Addendum No. 03

Date: October 21, 2025

Project: MSU Barnard 111 – Lithography Lab

SHEET
A101

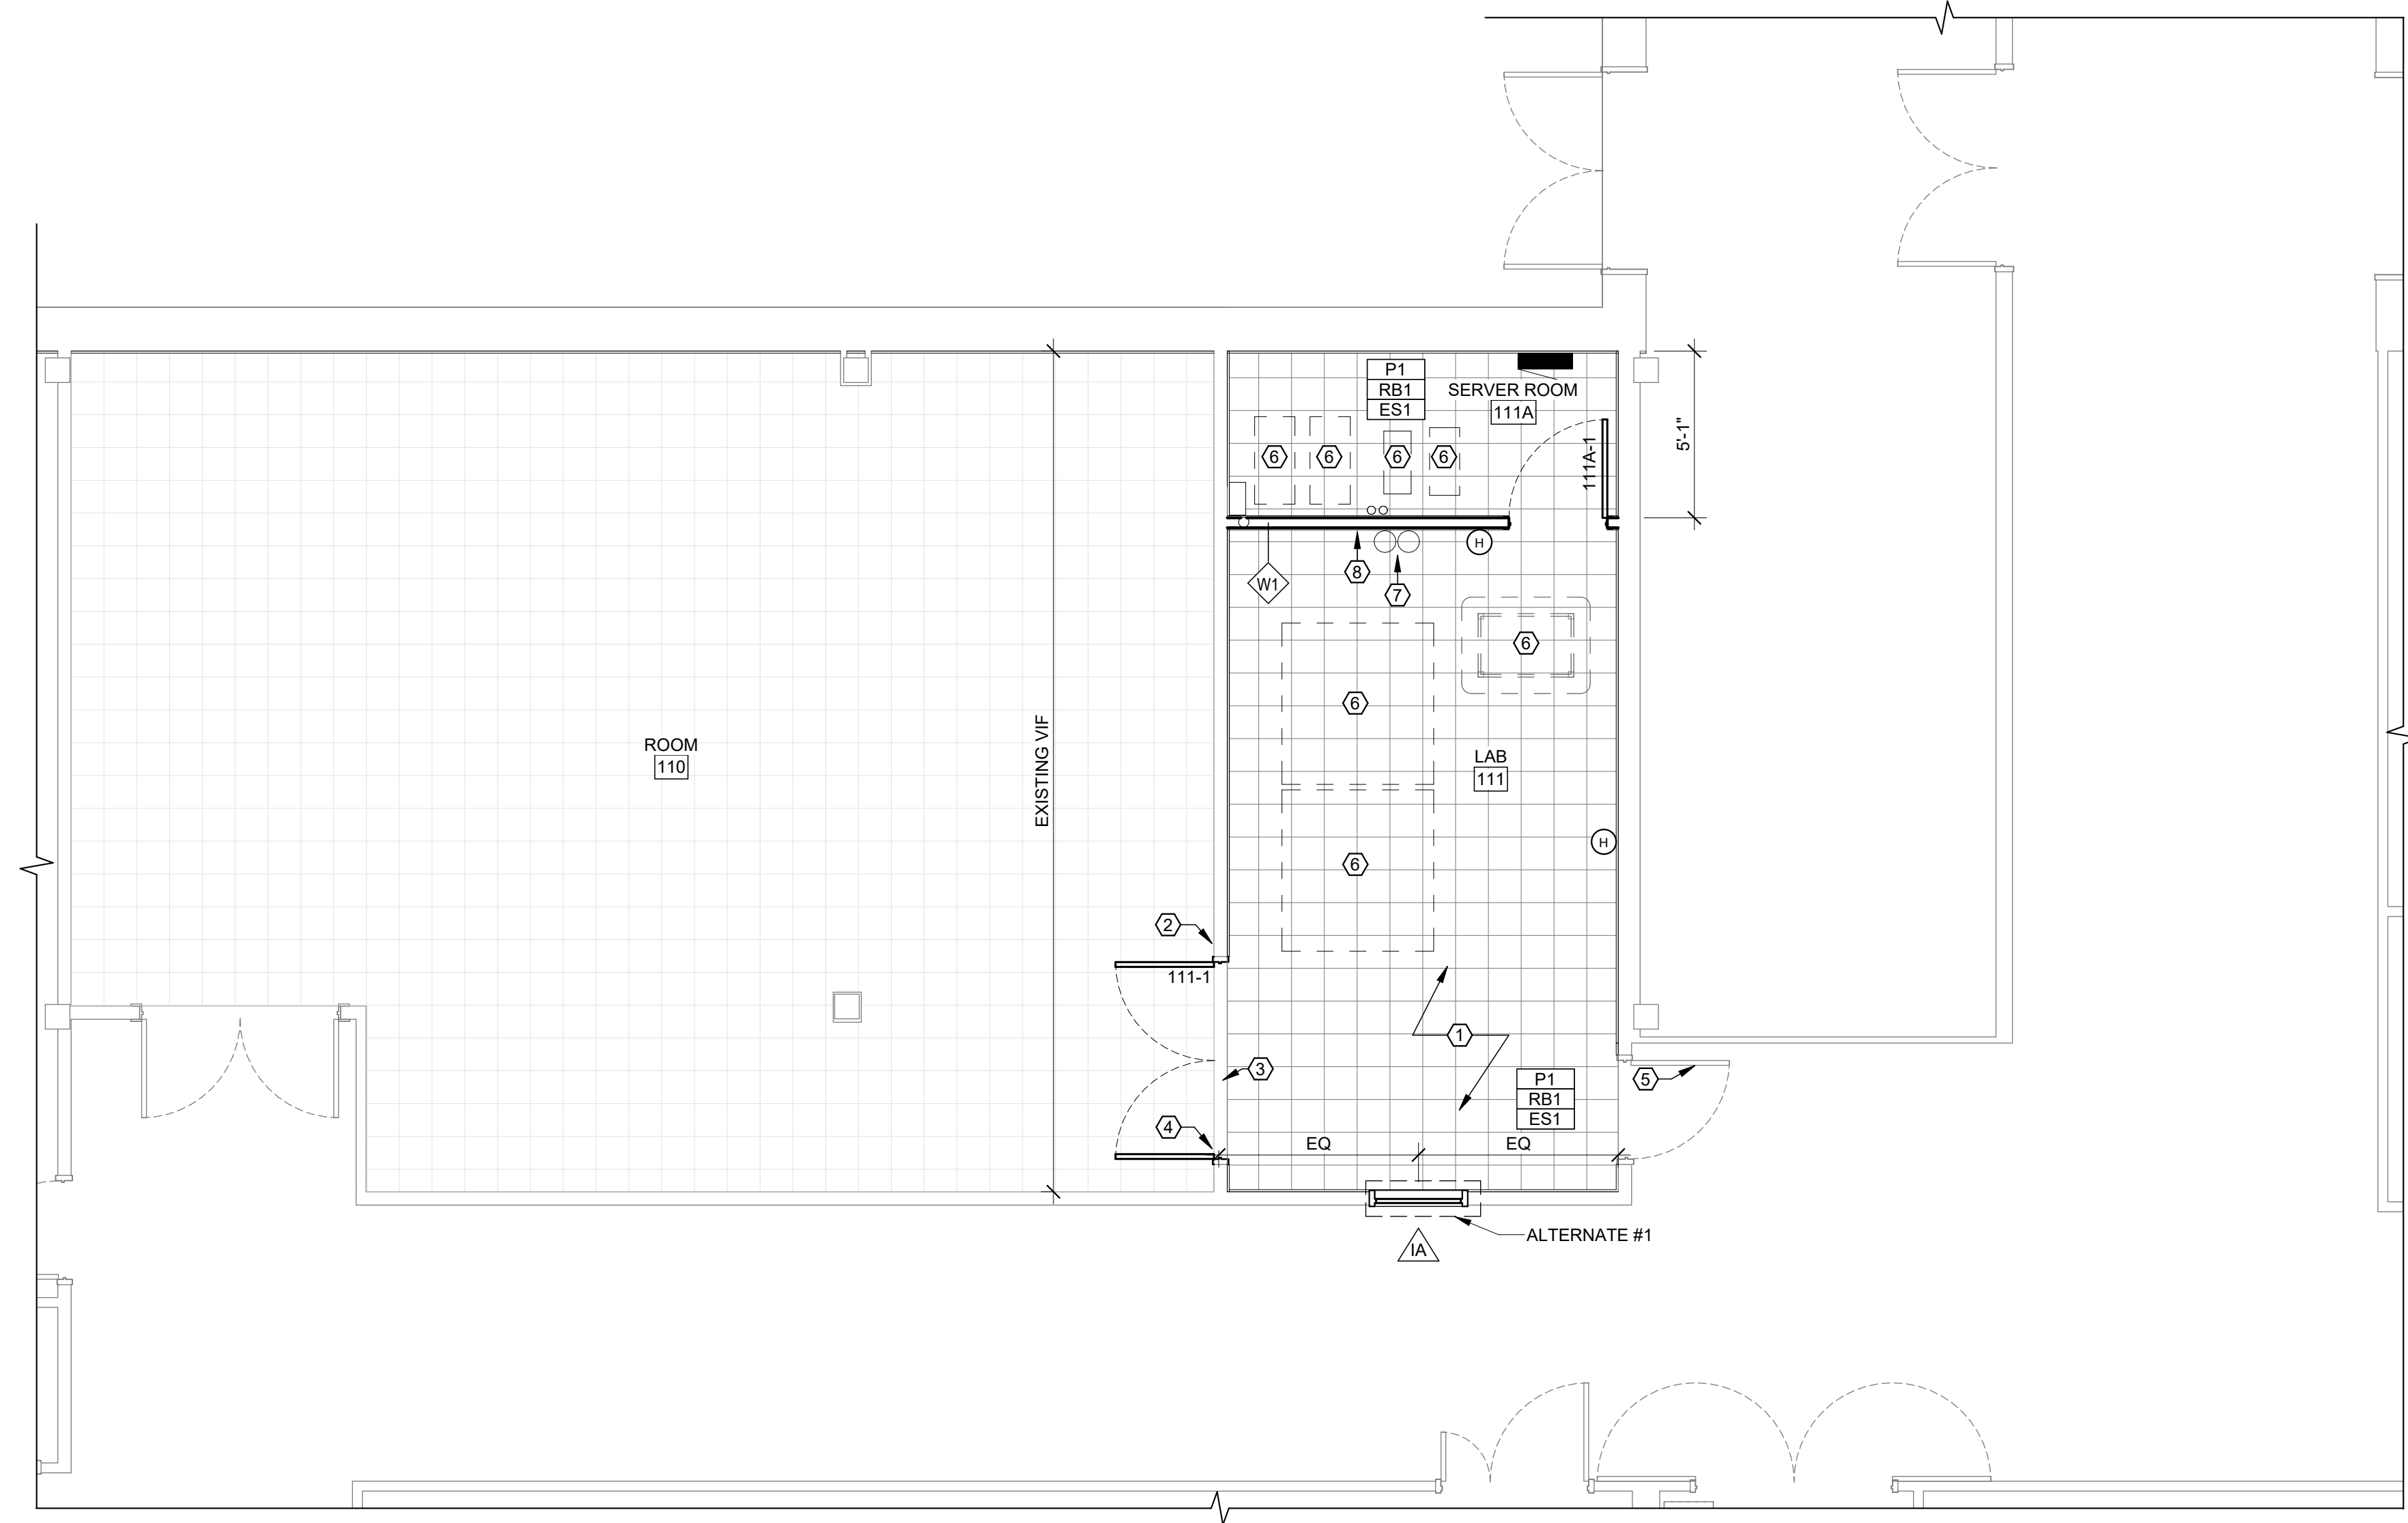
1. Where is the laydown area located? The laydown area will be determined between GC and MSU after bid is awarded.
2. What is the level of flatness required, and does it need to be tested? See revised A101 for additional information on floor flatness.

7. Please confirm that flooring is NOT to be removed at Room 110? Demo Note 1 only pertains to Lab 111 space? Flooring in room 110 will remain. Demo note 1 only pertains to Room 111.

- LEVEL SUBFLOOR PRIOR TO NEW FLOORING INSTALLATION. PROVIDE SELF LEVELING SUBSTRATE OVER EXISTING SUBFLOOR TO LEVEL OUT ALL UN-EVENNESS ACROSS THE ROOM. SEE FINISH SCHEDULE.

SHEET
A901

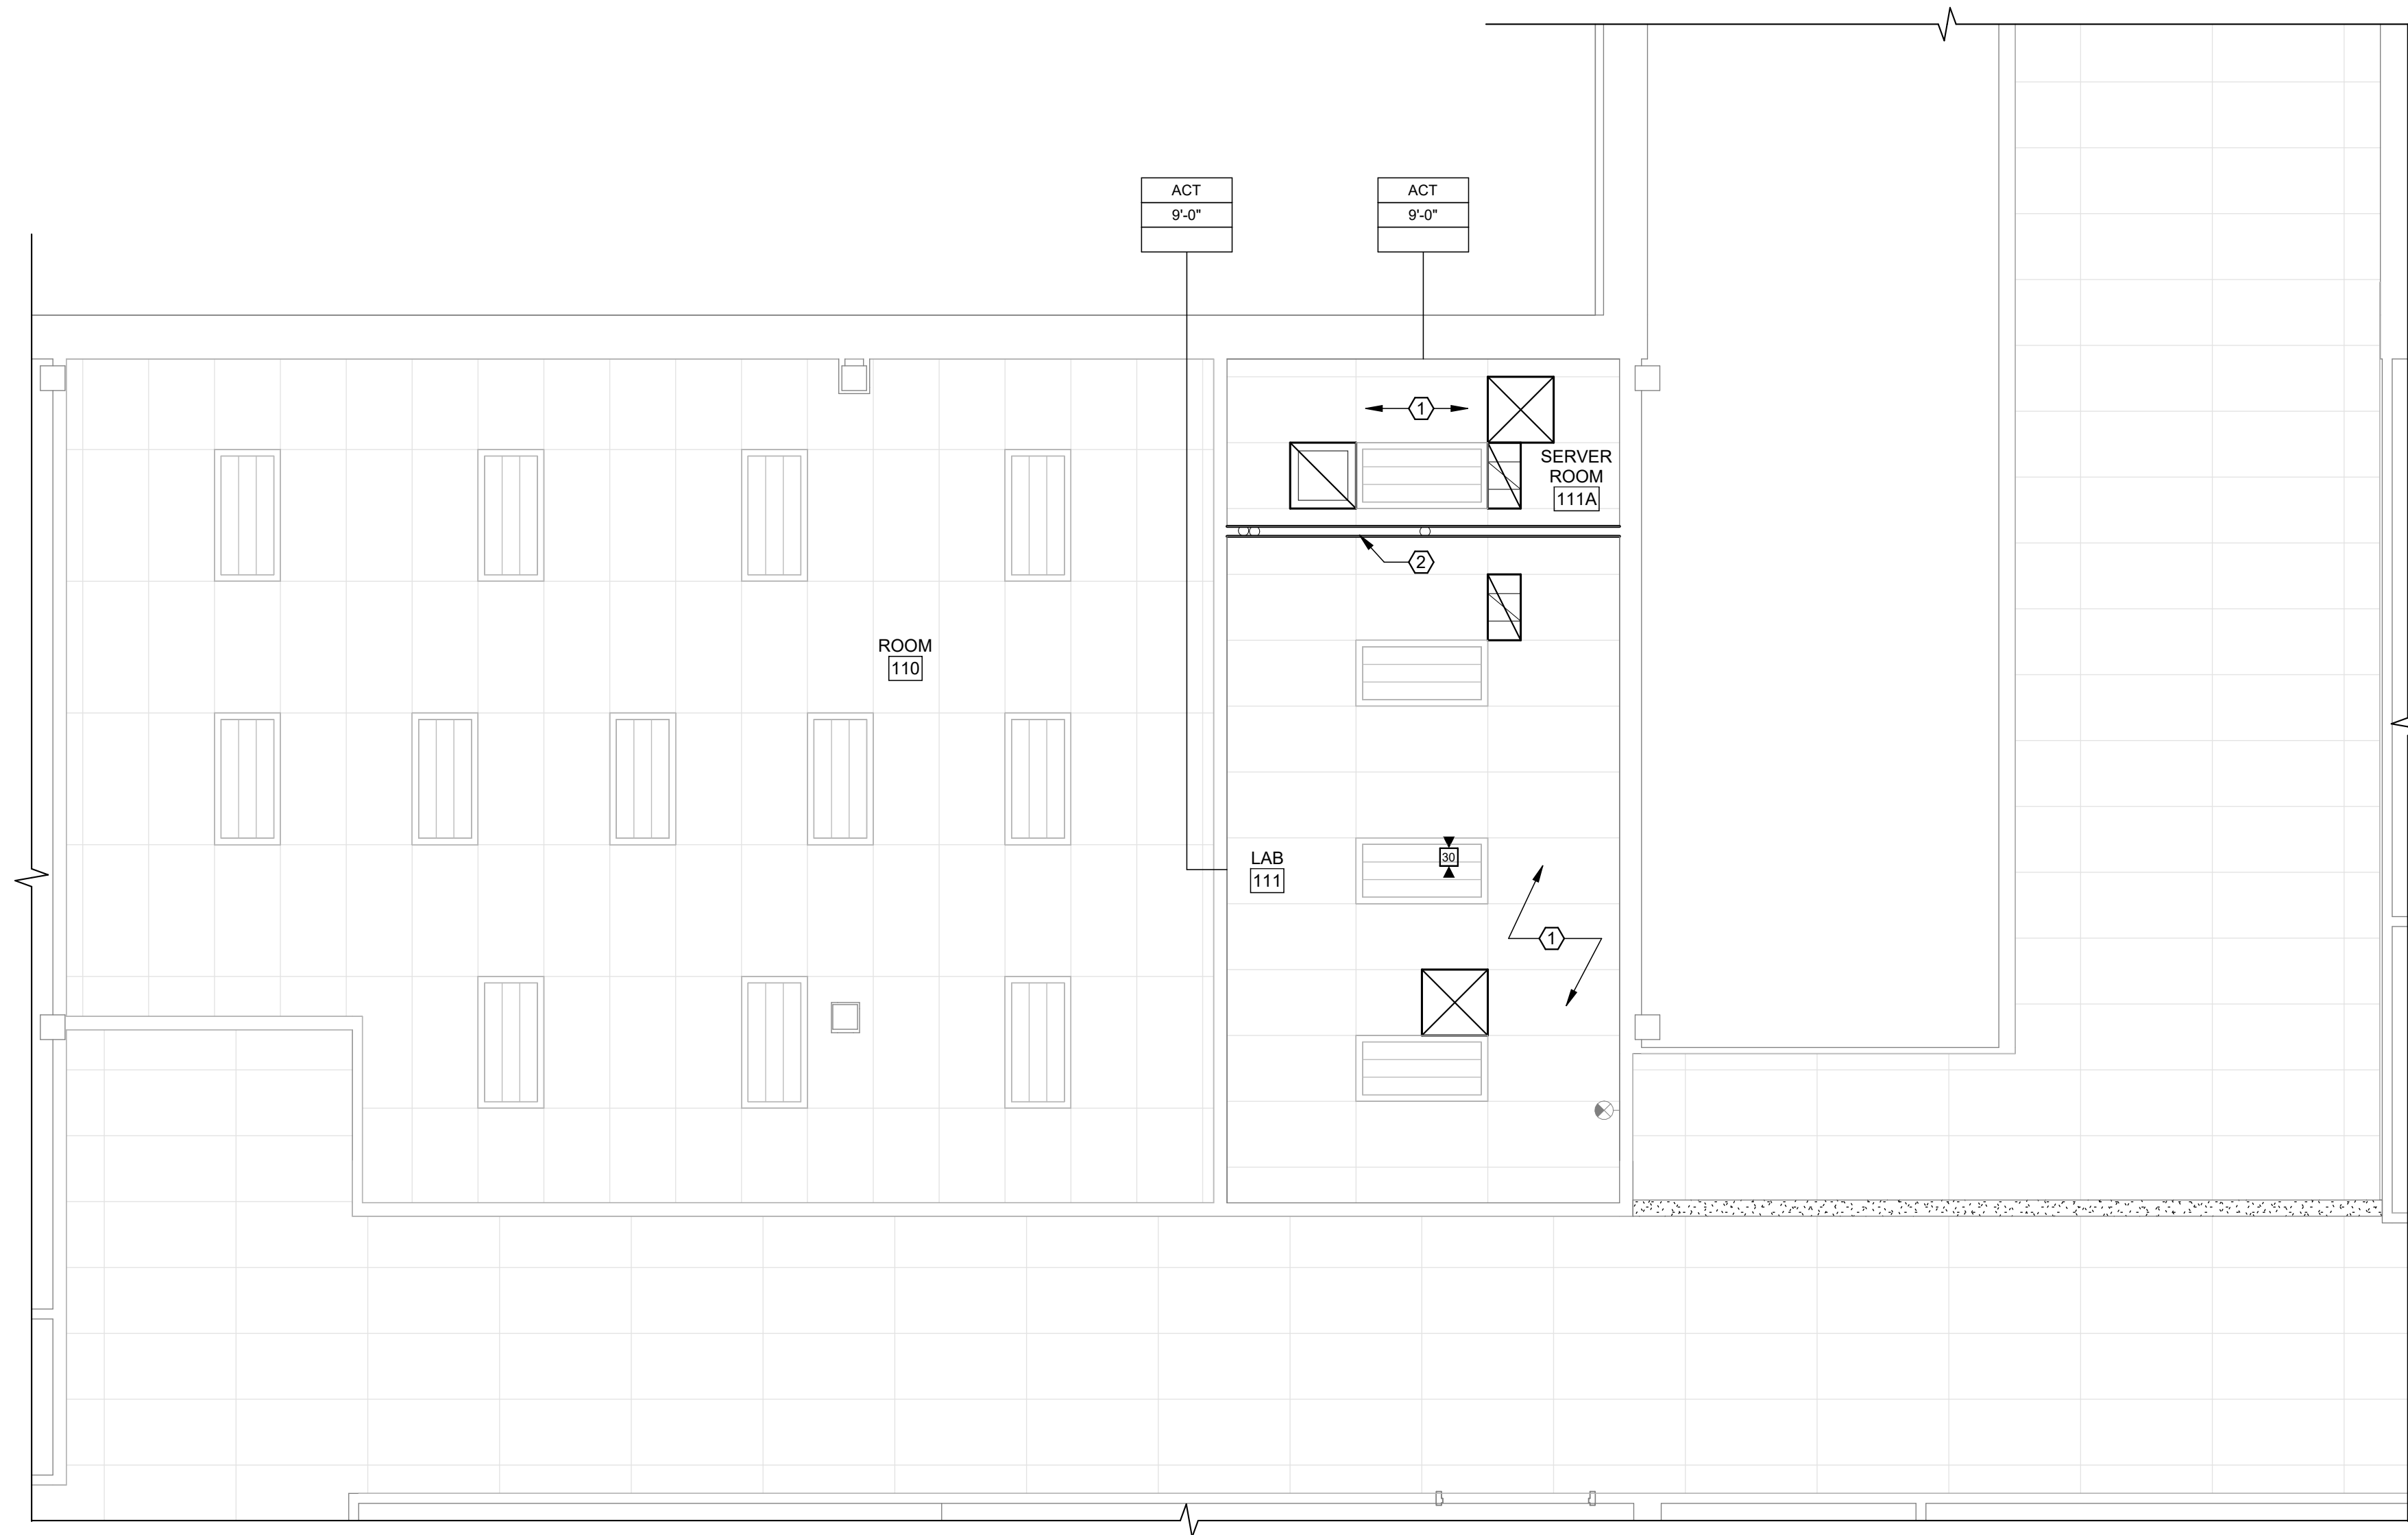
10. Is a specification available for the existing acoustical ceiling tiles? See revised A901 for the ACT basis of design (BOD).
11. Please confirm that entirety of Room 111 and 111A should be painted? Yes, all walls are called out to be painted in Rooms 111 and 111A.

- PROVIDE NEW CEILING TILE IN EXISTING GRID, TYP. ACT BOD: CERTAINTEED, SYMPHONY m 80 Rx, SIZE: 24" x 48", OR APPROVED EQUAL. EDGE OF TILE TO MATCH EXISTING.
- EXTEND WALL FINISH 8" ABOVE ACT GRID HEIGHT.
